INNER WEST COUNCIL

**Item 3 Sydney Eastern City Planning Panel Report: DA201700558:
1-9 Rich Street, Marrickville**

File Ref: DA201700558

Image 26: Sketch prepared by Peter Ireland, AEP Panelist

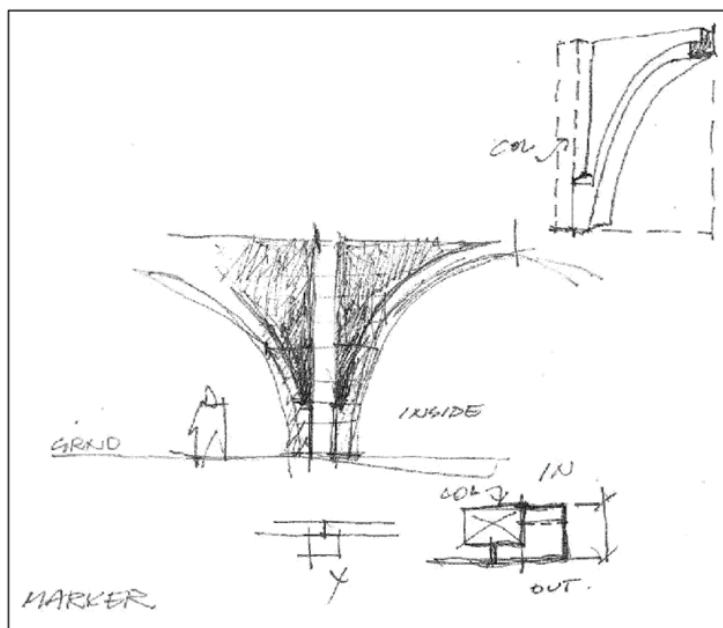
3. To help direct the design team's particular areas of focus, the Panel is concerned that pre-cast concrete - due to its relatively shallow depth - will not achieve an adequate sense of robustness, or the necessary quality of finish (specifically on the reverse face of ground level panels) to achieve a high quality architectural outcome along the colonnaded elements of the Marker and North Hub Buildings. The amended plans have not yet adequately addressed the Panel's concerns in the comments dated 20 November 2018 ...

4. It is recommended that further design development and elaboration of the colonnaded elements of the Marker and North Hub Buildings be provided. Please refer to a suggestion on one possible approach to resolve the colonnade treatment on the Marker and North Hub Building in the sketch attached. The objective inherent in the sketch is to achieve a more substantial sense of depth and material expression to the colonnades at Ground Level for each of the pre-cast concrete buildings.

Image 7: Marker Building Section Detail

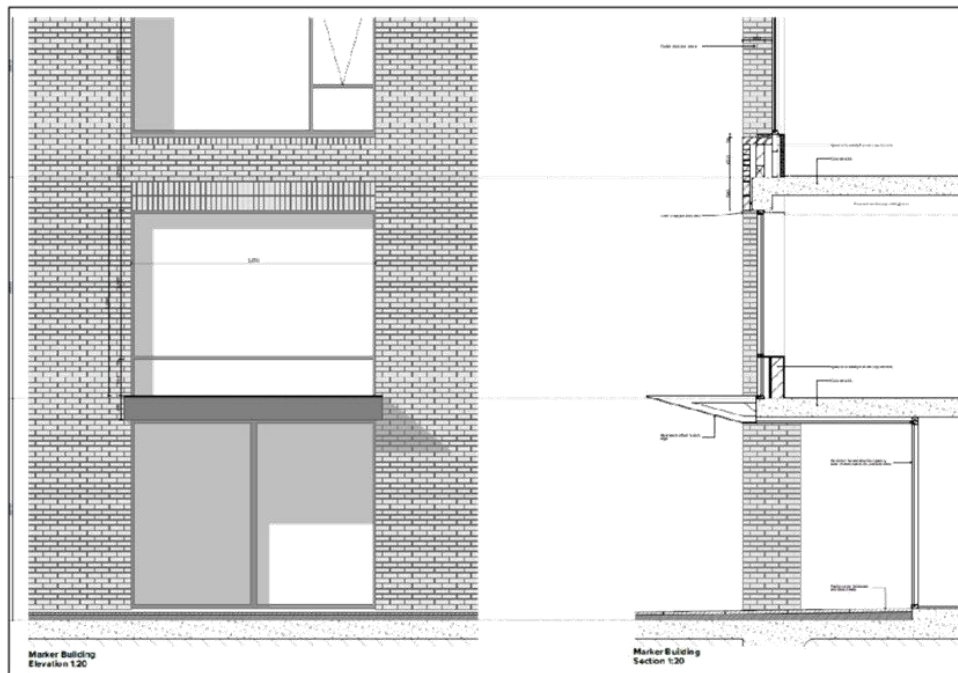
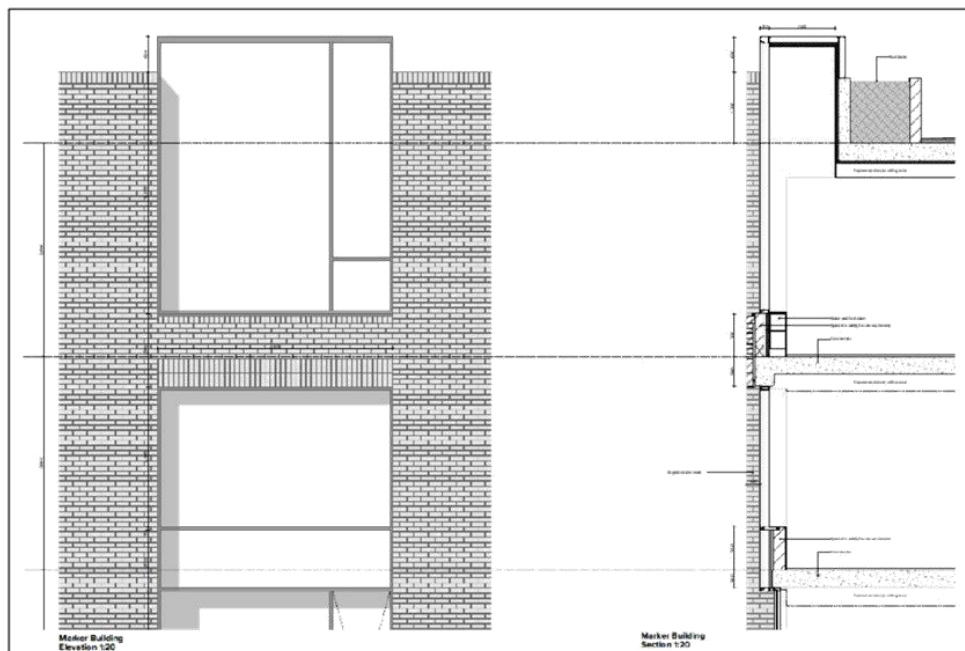
2. However, the Panel reiterates the following point - given their strong presence and proposed public uses, further design development of the Marker and North Hub Buildings is warranted in order to provide Council with greater certainty of the expected level of architectural quality through execution. This is particularly relevant at the buildings' most public interface - the colonnades at Ground Level. The amended plans for the Marker and North Hub Buildings have not yet adequately addressed the Panel's concerns.

Having regard to the information provided above and Council's insistence in directing the applicant towards achieving design excellence, Council is not satisfied that the Marker building which is contained within Stage 2 of the development would result in a high quality architectural outcome for the site. The amendments to the plans that were provided towards the end of the assessment appear to address a number of concerns that have been raised during the process. However, the lack of co-operation by the applicant to change the façade of the Marker Building remains the unsatisfactorily resolved issue with the development from a design excellence standpoint which will leave a distinctive mark as the first project within an important revitalisation precinct of the Inner West. Council accept the subjective nature of architectural excellence and therefore leave this decision at the discretion of the consent authority to determine if this element of the application is acceptable.
